Title: PSI 8.8L Exhaust Manifold Reuse Guidelines

Applies To: PSI 8.8L engines

This document will guide the user through the exhaust manifold inspection process and cover the change in the exhaust manifold installation procedure to prevent damage due to thermal expansion. This procedure should be performed anytime the exhaust manifold is removed for any reason.

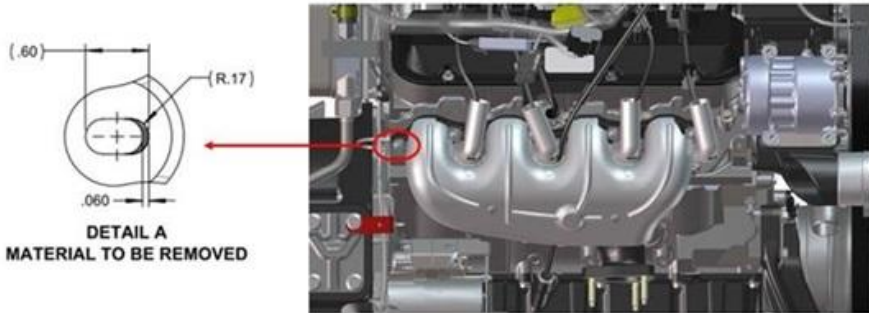
1. Inspect the manifold for any damage or cracks. If damage or cracks are found, replace the exhaust manifold.
2. Remove all gasket material, carbon buildup, and/or other foreign material from the exhaust manifold sealing surface.
3. Using a precision flat bar or plate (must be the length of the manifold runner), secure the manifold on the two middle runner flanges as indicated in the illustration below.

4. Using a feeler gauge, measure the flatness under each surface individually. Maximum tolerance across each individual runner mounting surface is a 0.004" (inch) gap per runner.
5. Using a feeler gauge, measure the flatness of each runner compared to the other 3 runners. Maximum tolerance across all runner mounting surfaces (4 total) is 0.010" (inch) gap.

NOTE: If flatness exceeds the allowable tolerance, resurface the manifold mating flanges. The resurfacing operation should maintain the tolerances while removing a maximum of 0.020" (inch) in flange depth. The surface finish of the machined face should be 125 microinches.
